AMENDMENT NO. 1 MAY 2026

IS 17740 : 2022 ISOLATED TOWERS, MASTS AND POLES USING STRUCTURAL STEEL — CODE OF PRACTICE

15.2.7 For polygonal members, w/t shall not exceed $2.14 \left(\sqrt{\frac{E}{F_y}} \right)$.

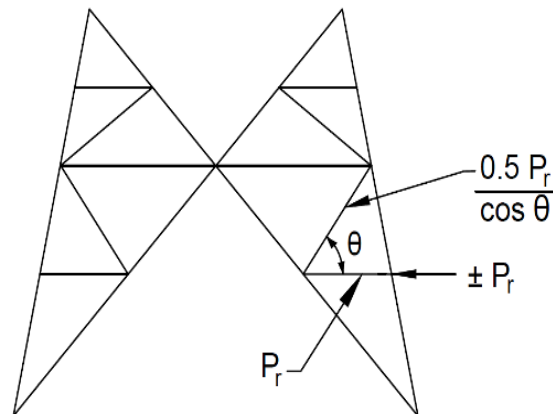
(Page 25, clause 15.2.5) — Insert the following at the end:

‘15.2.6 For tubular round members, the diameter to thickness ratio (D_o/t) shall not exceed 300’.

15.2.8 Polygonal members with more than 18 sides, shall be considered as round members for strength investigation purposes using a diameter equal to distance across flats.

15.2.9 While designing the pole structure, the D_o/t ratio and w/t ratio, shall be maintained properly to avoid buckling and ovality of the individual sections of the pole structure under load during transportation and handling.

- D_o = outside diameter of section;
- w = width of side; and
- t = thickness of sheet.’
